**RE: Site Plan Review Modification
Approved Tractor Supply Company
0 Hillside Avenue (M/B/L: 124/180/1A)
Watertown, Connecticut 06779**

To: Spencer Musselman, Administrator for Land Use and Building Services/ZEO

From: Paul Bunevich, Town Engineer

I have reviewed the latest Site Plans (23 sheets total) dated 05/23/25 as revised to 3/10/26, by Solli Engineering for the above referenced project. I have the following comments for your consideration:

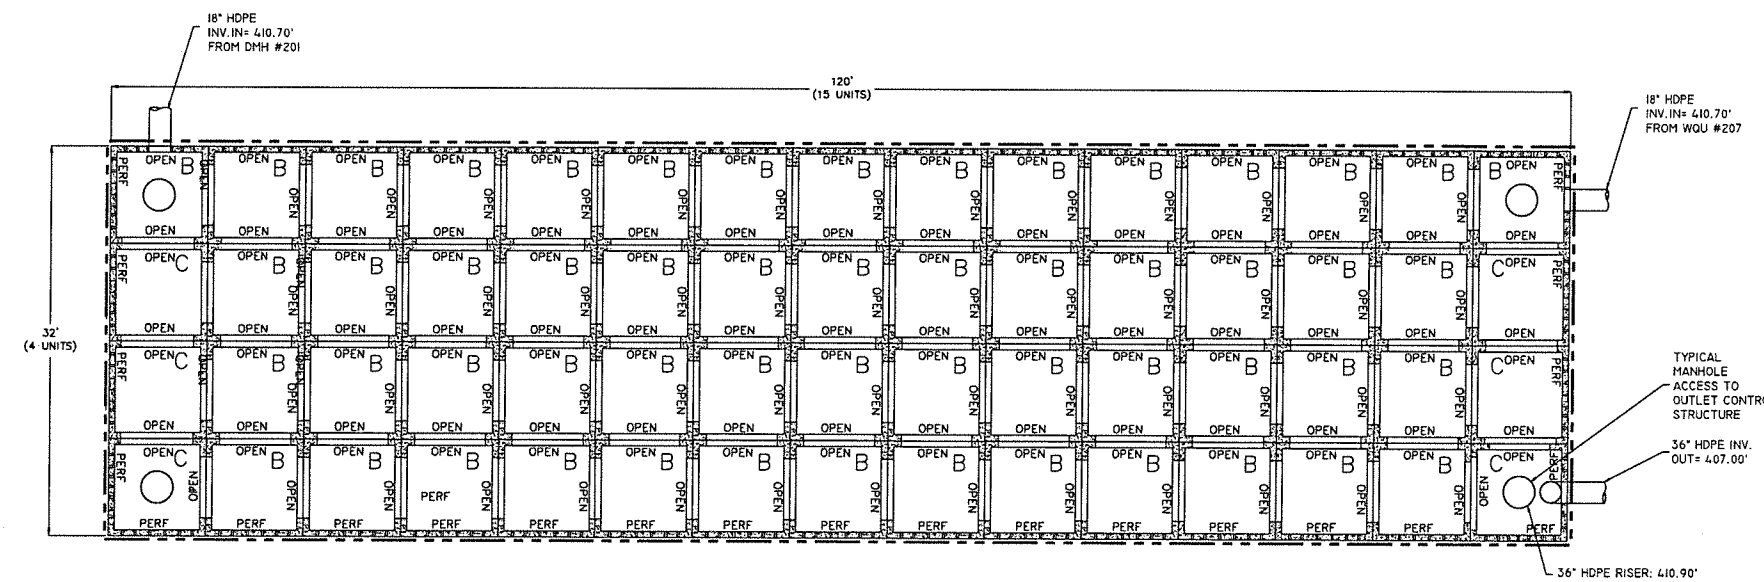
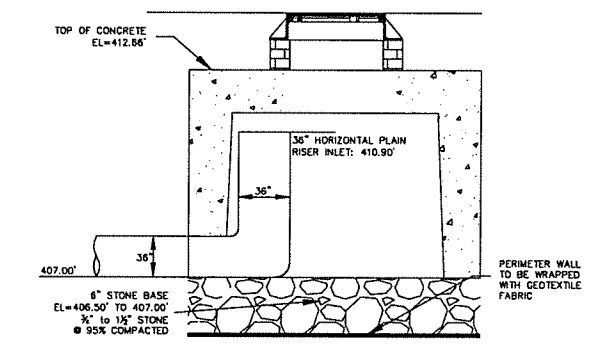
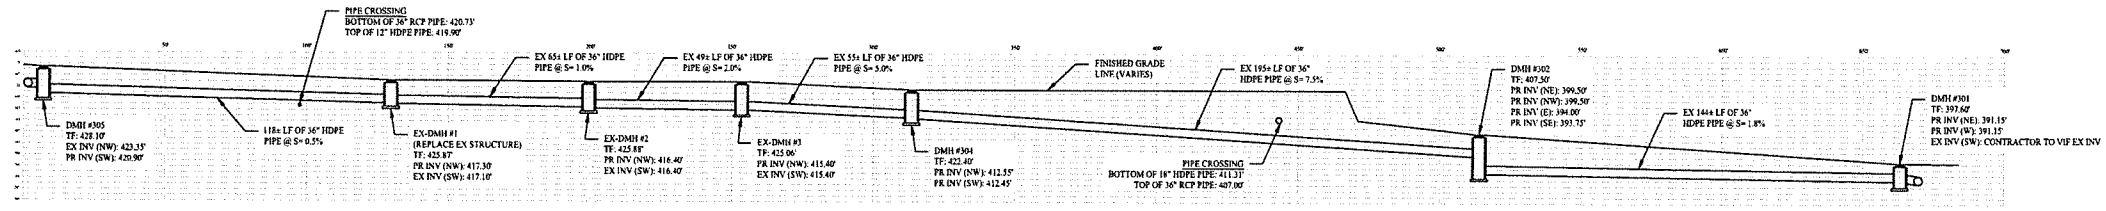
- 1) The revised Plans show an underground infiltration system in lieu of the previously approved water quality pond. Some issues with the new system are

- d) The system grading should provide for a level five foot shelf on the downgradient side of the infiltrators to reduce the possibility of stormwater bleed out leading to eroding of the downslope.

- e) The Stormwater System Detail on Sheet 2.22 should show the extent of the stone surrounding the units.
